What we heard report

Stage 1 public consultation: Draft Lachlan Valley Floodplain Management Plan

September 2026

Figure 8: Refinements made to the proposed floodway network north of Lake Cowal

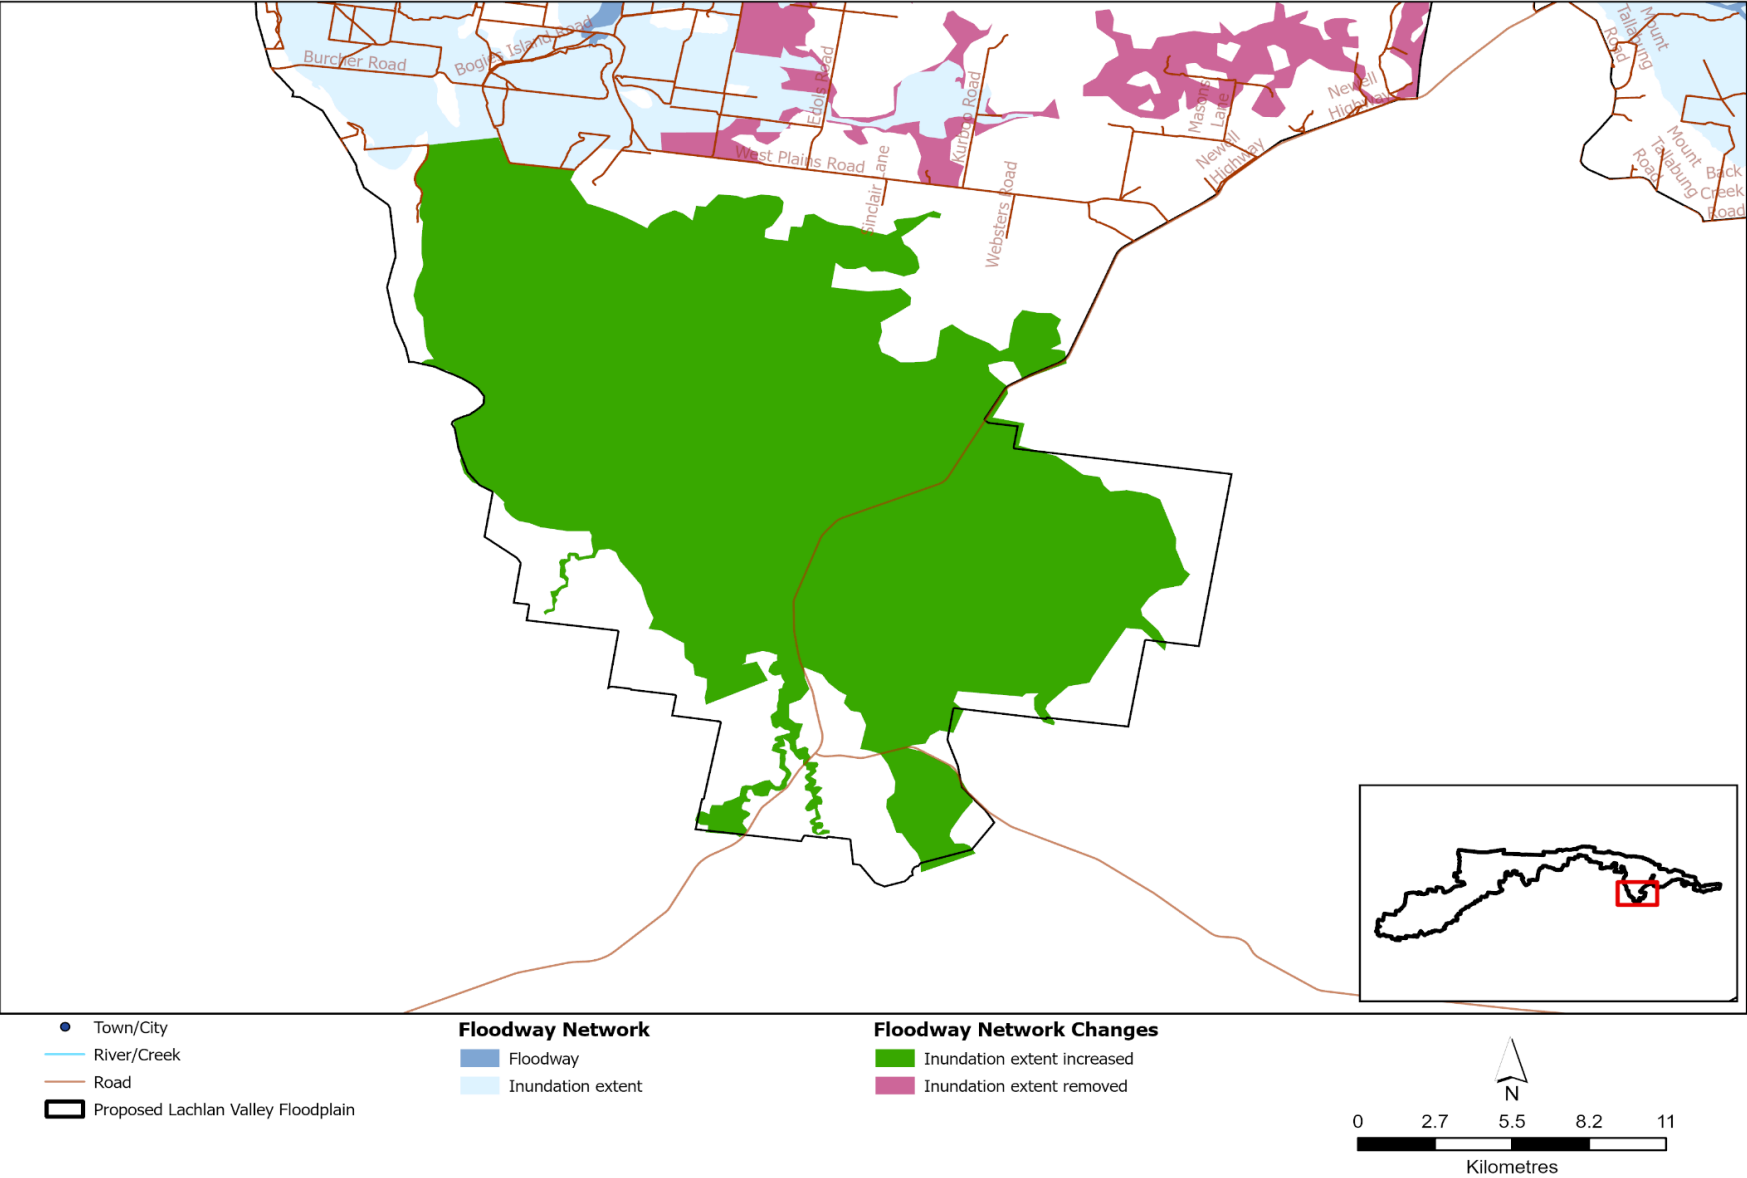
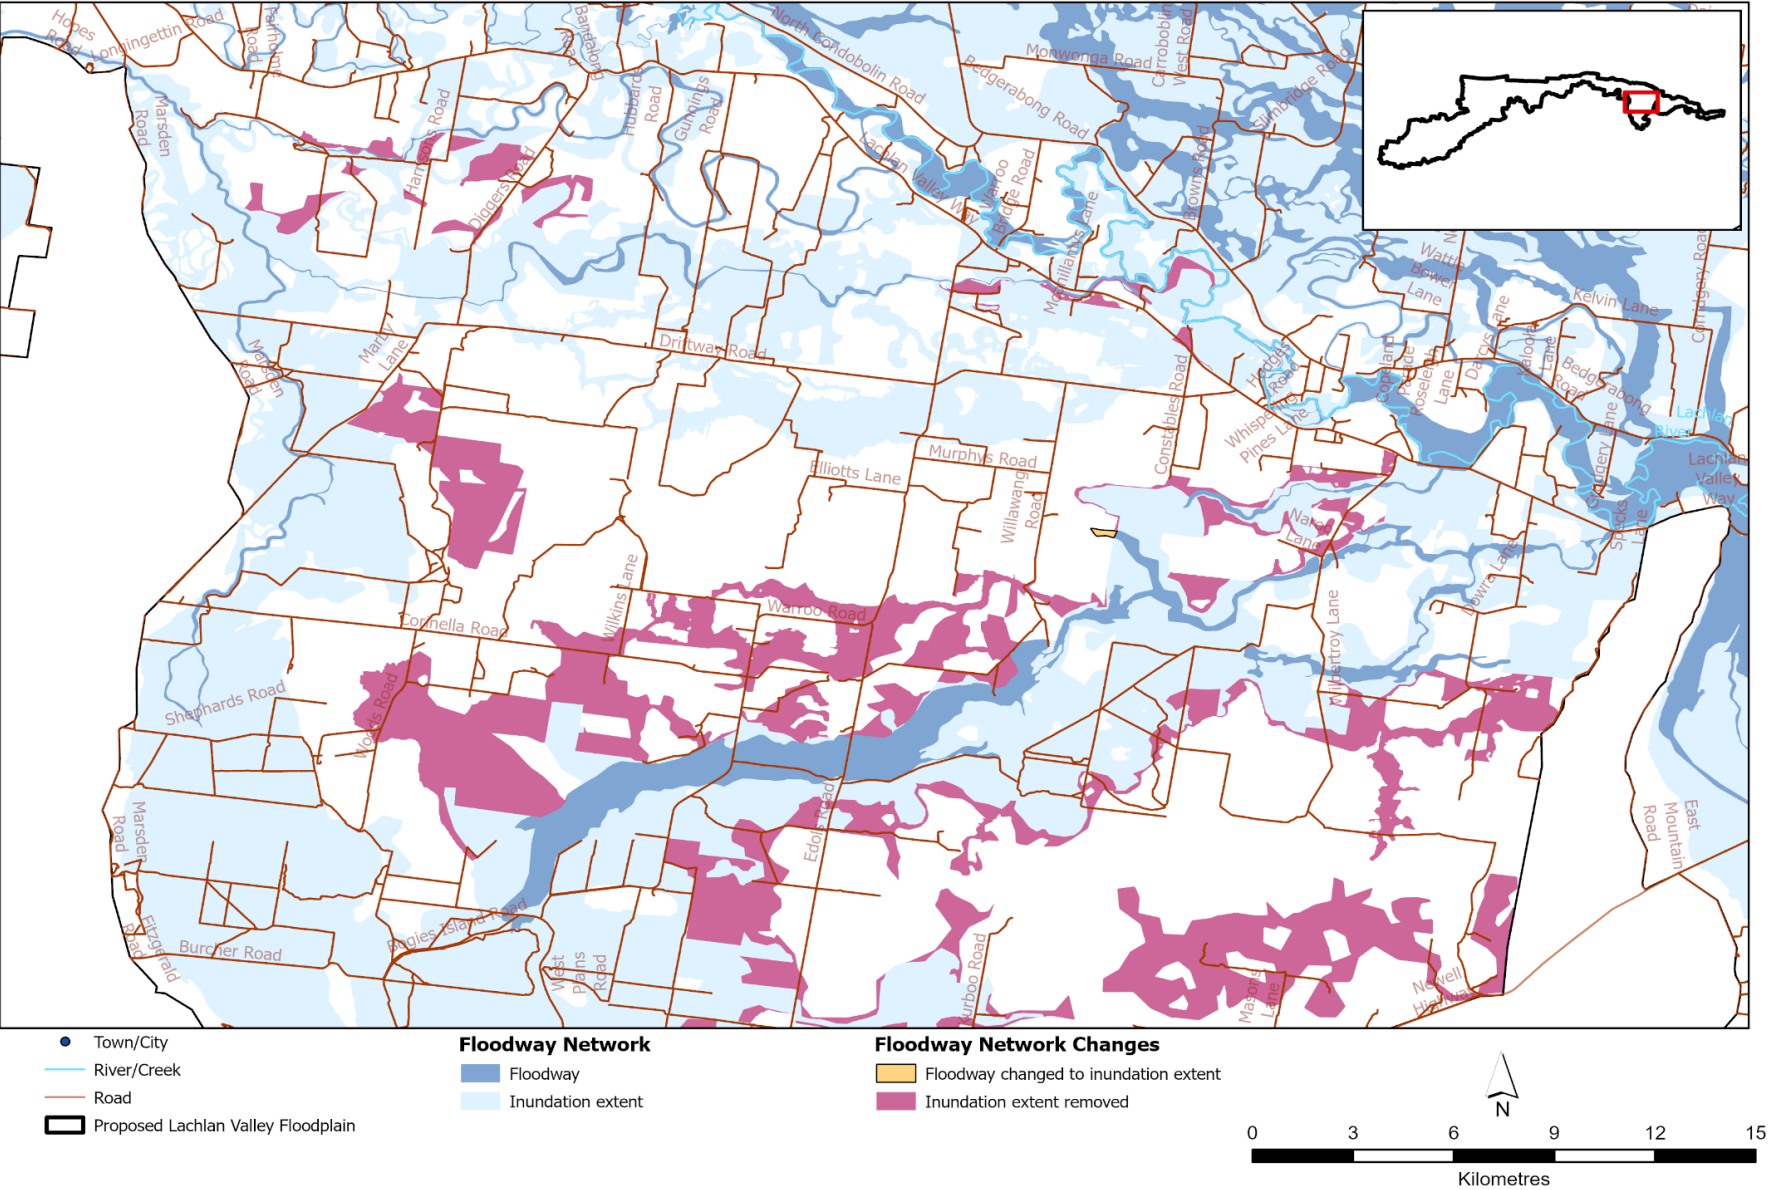
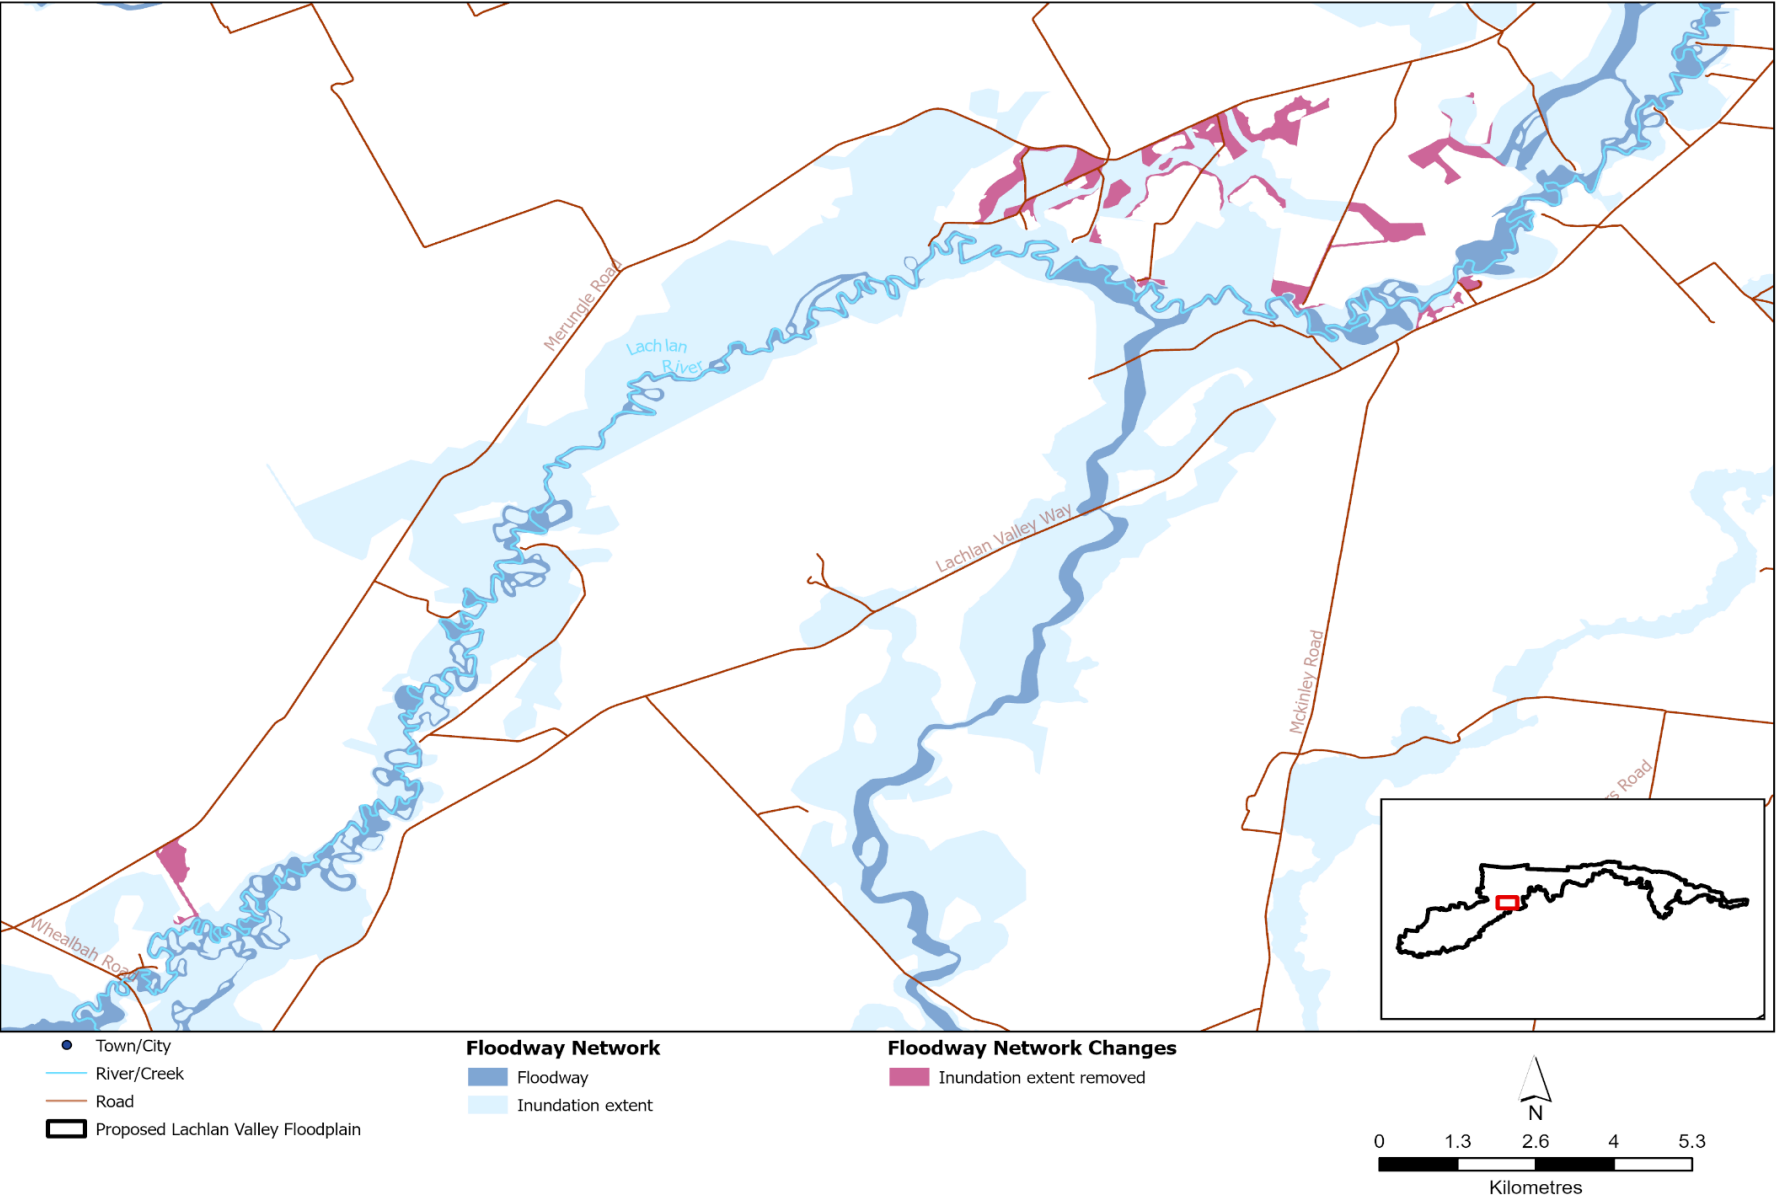
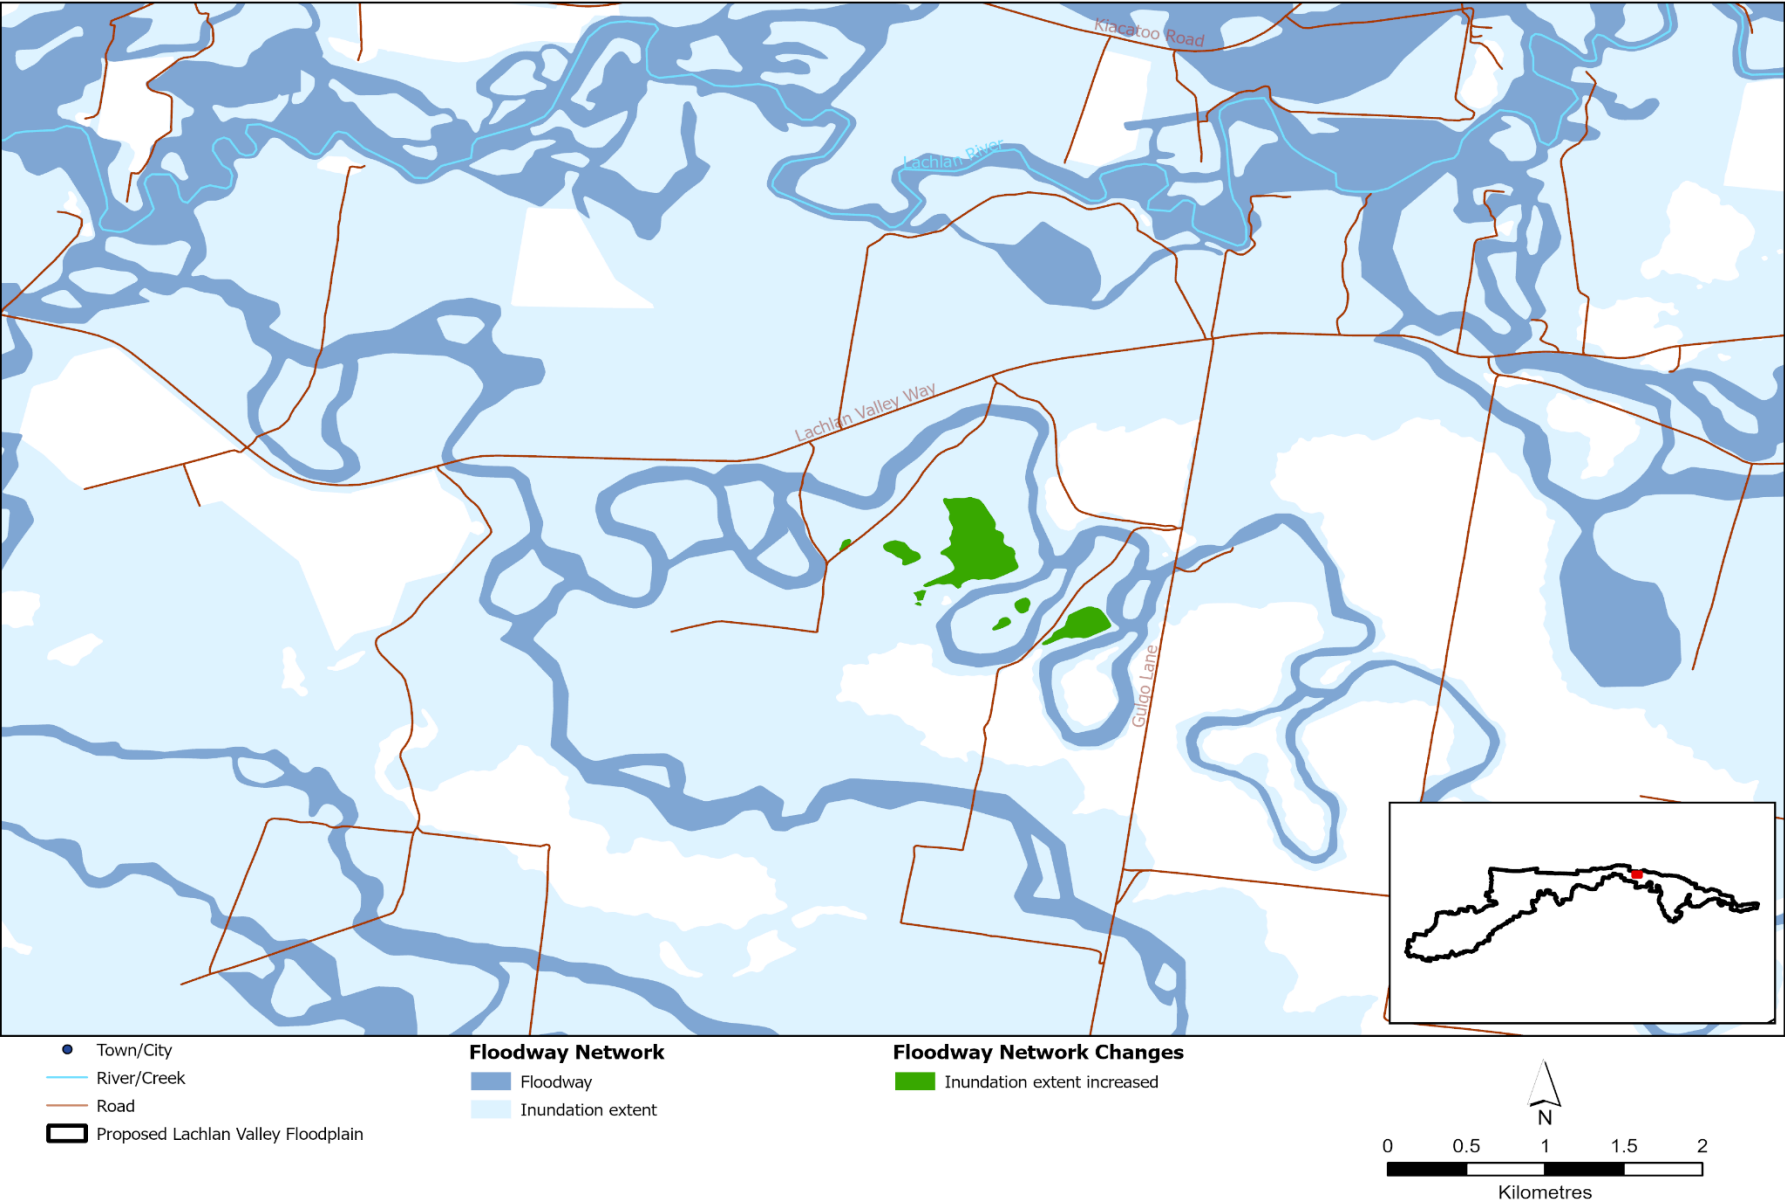
Feedback	Departmental response
Missing floodways from previous plans. There are several foodways that are completely missing from the draft plan, for example Greens Creek downstream of Forbes, and upstream from Jemalong gap.	In response to feedback, we updated the hydraulic model to better reflect the historical FMPs. Spatial refinements that resulted from this model update are shown in Figures 3 to 14 in Appendix 2.
The proposed floodway boundary near Lake Cowal is significantly narrower than the existing floodway. In our view, this may reduce the floodway's ability to convey and redistribute flood flows, increasing the risk of flood impacts and infrastructure failure.	See response above.
Local observations and on-ground validation should be used to validate, refine, and finalise modelling outputs.	Agree. Modelling outputs are validated using satellite imagery, surveying results, LiDAR and topographical information. Further, site-specific information and local flood knowledge provided through consultation, including information relating to flood behaviour, historical inundation and floodplain infrastructure in the identified areas, is considered during ongoing refinement of the proposed floodplain boundary and associated mapping.

We should follow the same guidelines that were used to approve flood works in past floodplain management plans to avoid operational changes and cost blowouts to landholders and communities.	See response above. In response to feedback, we updated the hydraulic model to better reflect the historical FMPs. The spatial refinements that resulted from this model update are shown in Figures 3 to 14 in Appendix 2.

Figures 3 to 14 provide an overview of refinements to the proposed floodway network in response to stakeholder feedback and updates to the hydraulic model to better reflect the historical FMPs.
